City of Portsmouth Planning Board

Property Address: 238 Austin St.

Application #: LU-25-177

238 Austin St
Subdivision Application
Project Description

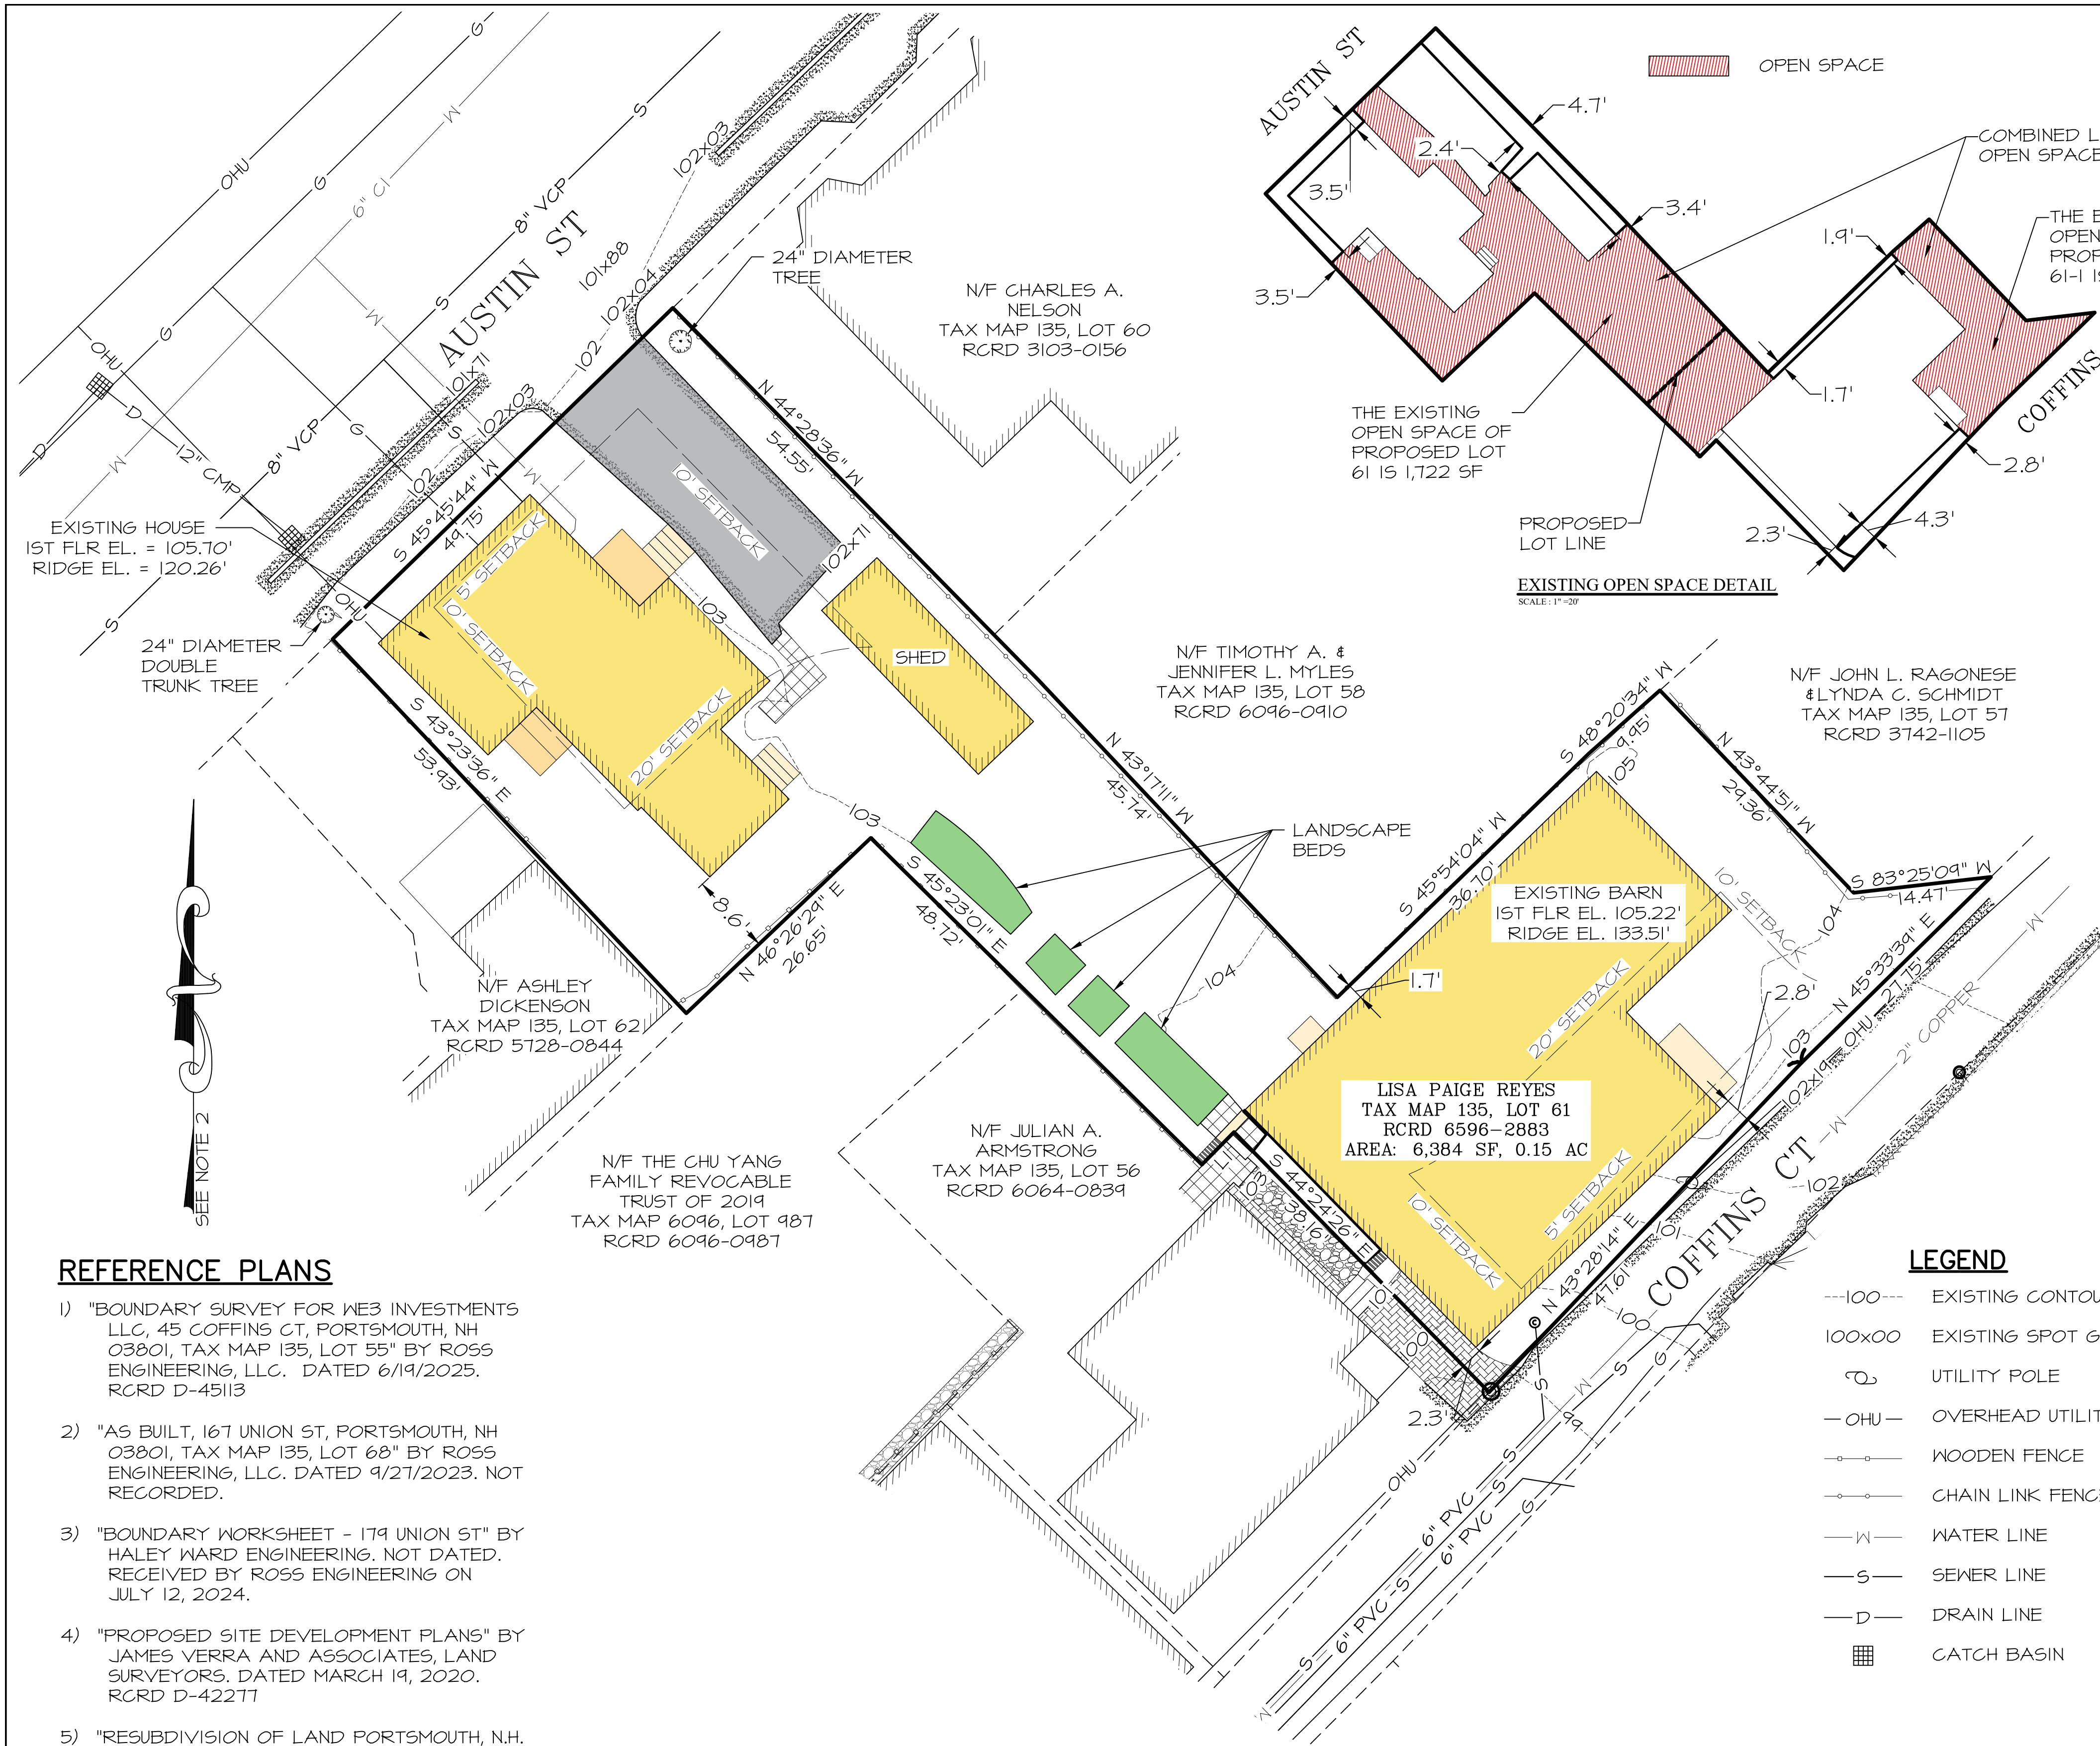
5. *Show spot grades in the gutter line and for the sidewalk crossing of Austin Street to ensure compliance with ADA rules.*

Existing spot grades have been added to Drawings 1, 3 and 4. Proposed spot grades on the northern side of the sidewalk have been added to lift the grade to meet the cross slope requirements. The southern side of the sidewalk shall remain at existing grade.

SUBDIVISION PLAN

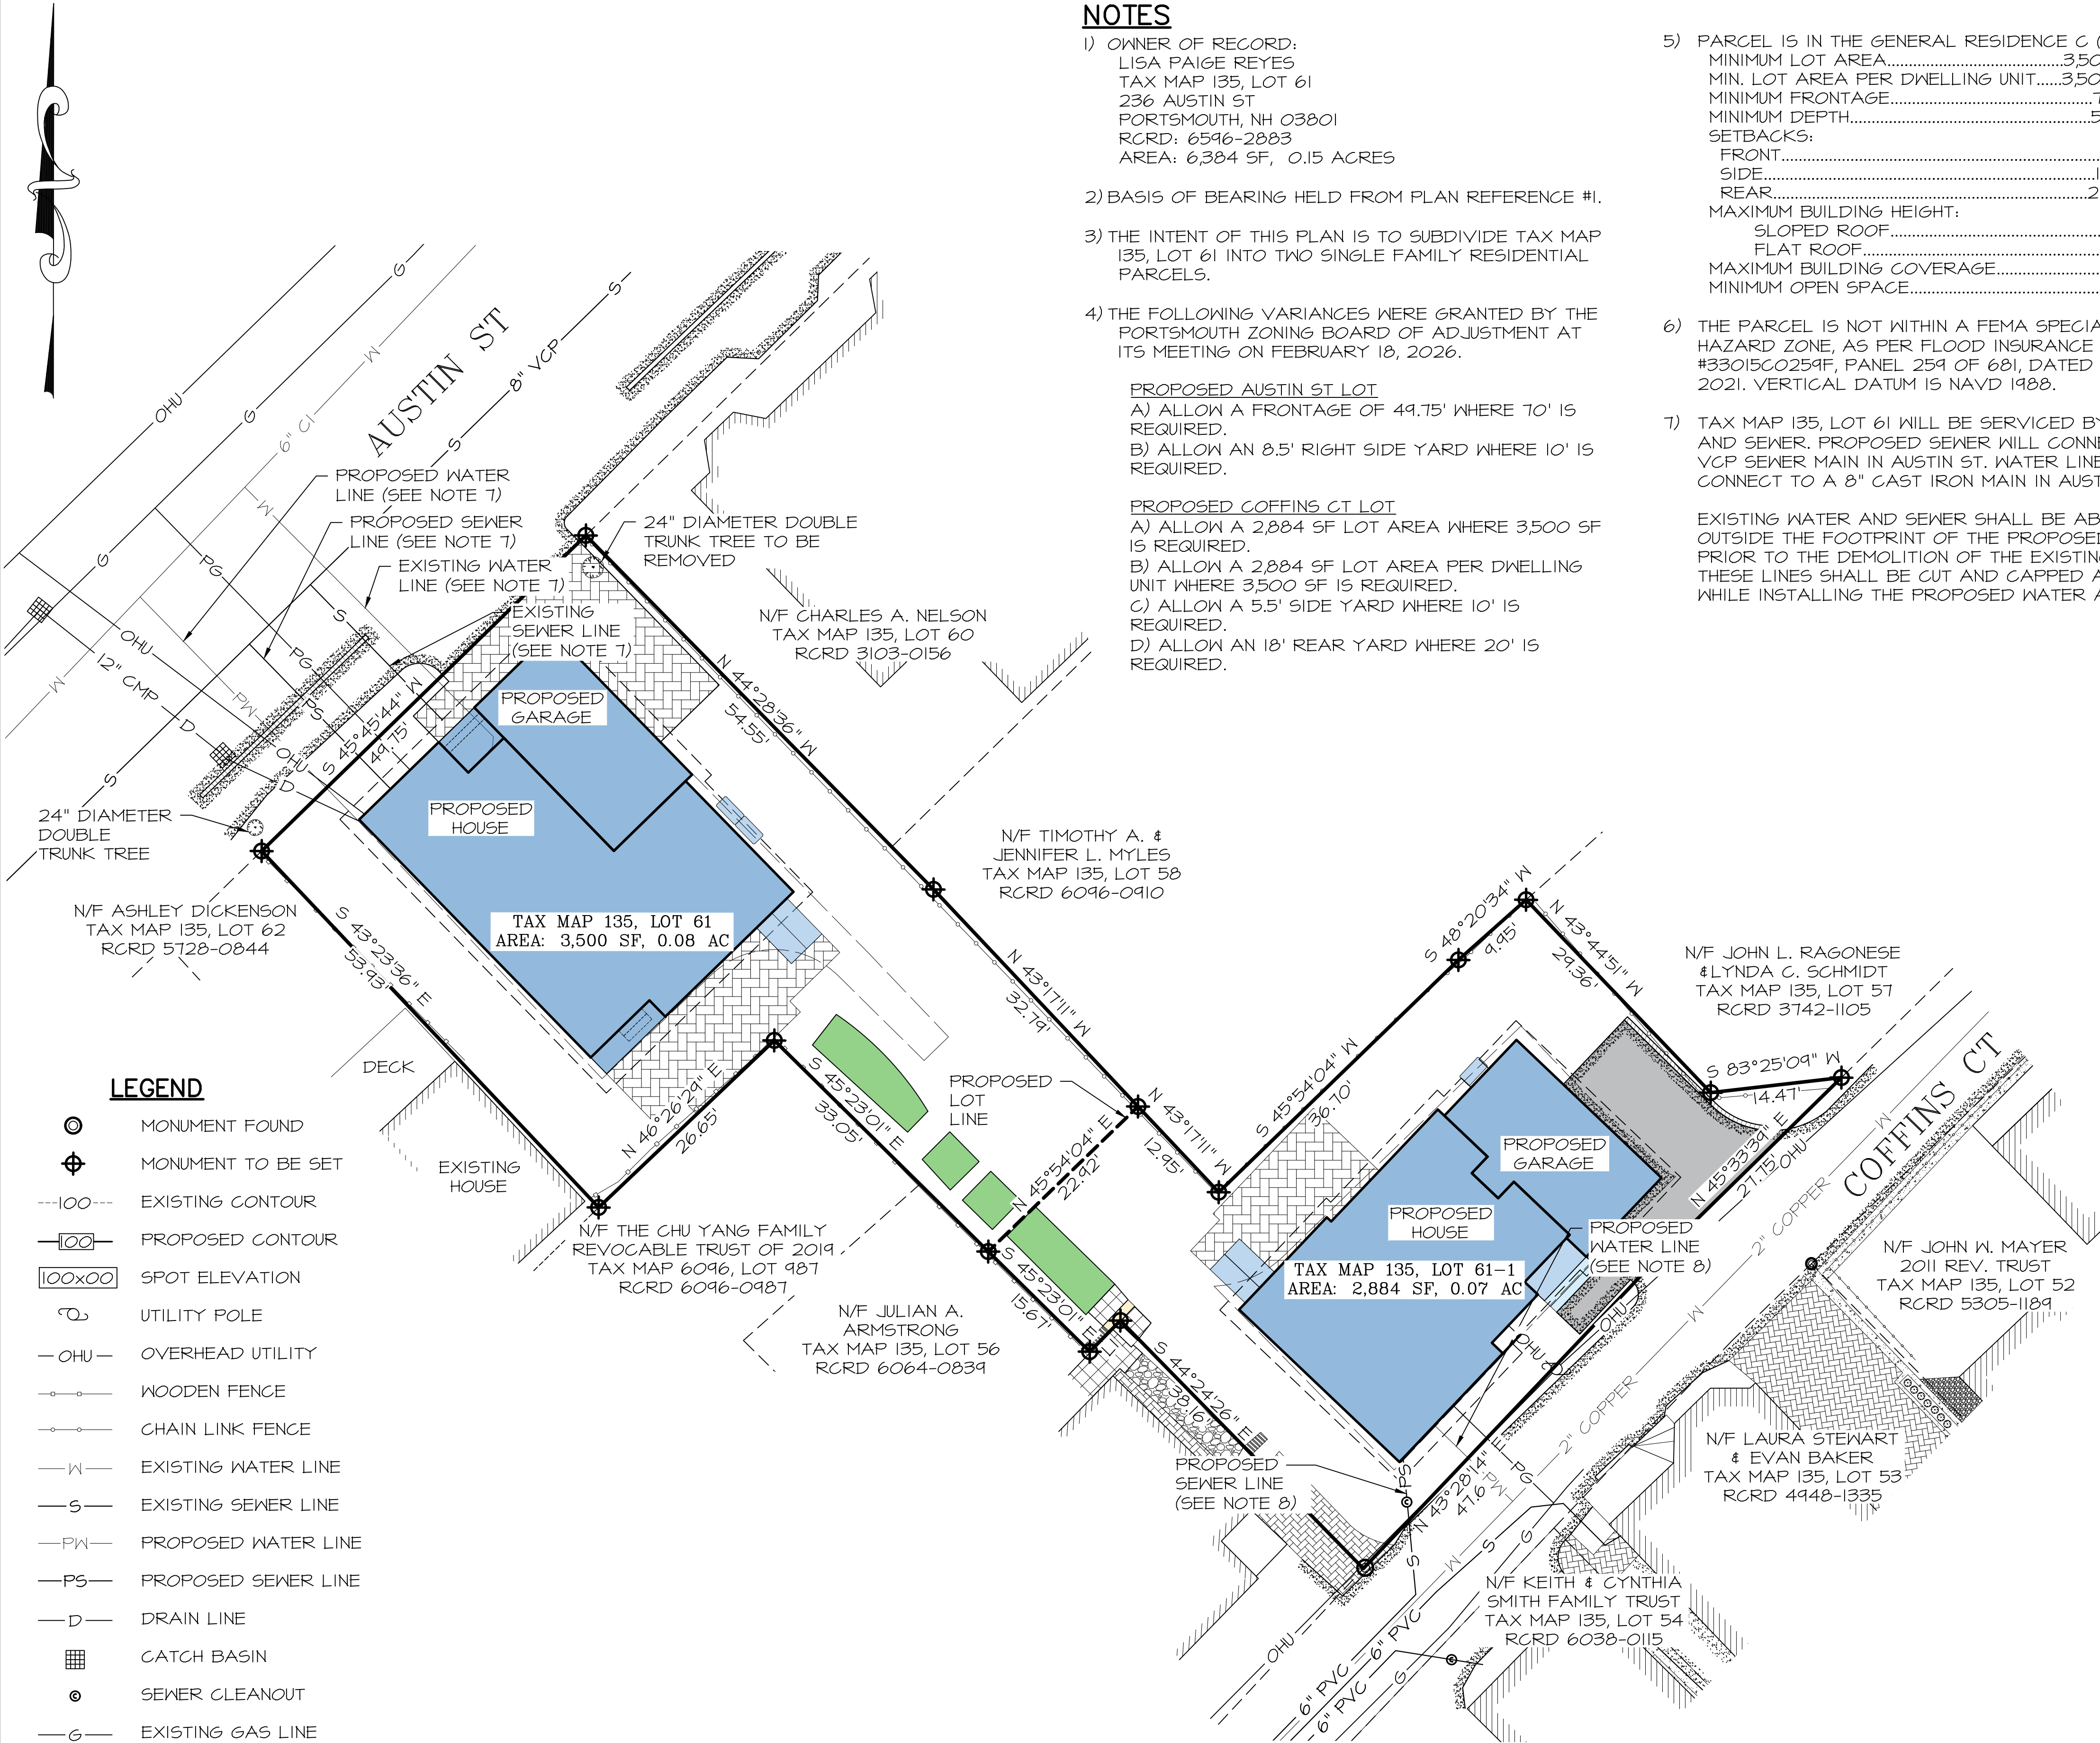
11. *Barn must be removed prior to recordation of the subdivision plan.*

10) ALL NECESSARY CITY PERMITS MUST BE OBTAINED INCLUDING:
• BUILDING PERMITS
• DRIVEWAY PERMITS.
• A CONSTRUCTION MANAGEMENT & MITIGATION PLAN (CMMP) IS REQUIRED.
• A PRE-CONSTRUCTION SURVEY & VIBRATION MONITORING IS REQUIRED DURING DEMOLITION & THE FOUNDATION STAGE OF CONSTRUCTION.
• COMPLY WITH APPLICABLE ROADWAY RESTORATION PER DPW & SURETY REQUIREMENTS FOR ANY DISTURBANCE OF COFFINS COURT.

11) THE DEMOLITION OF THE BARN WILL BE REQUIRED PRIOR TO RECORDATION OF THE SUBDIVISION PLAN.

Note 11 on Drawing 2, has been revised to state that the demolition of the barn will be required prior to recordation of the subdivision plan.
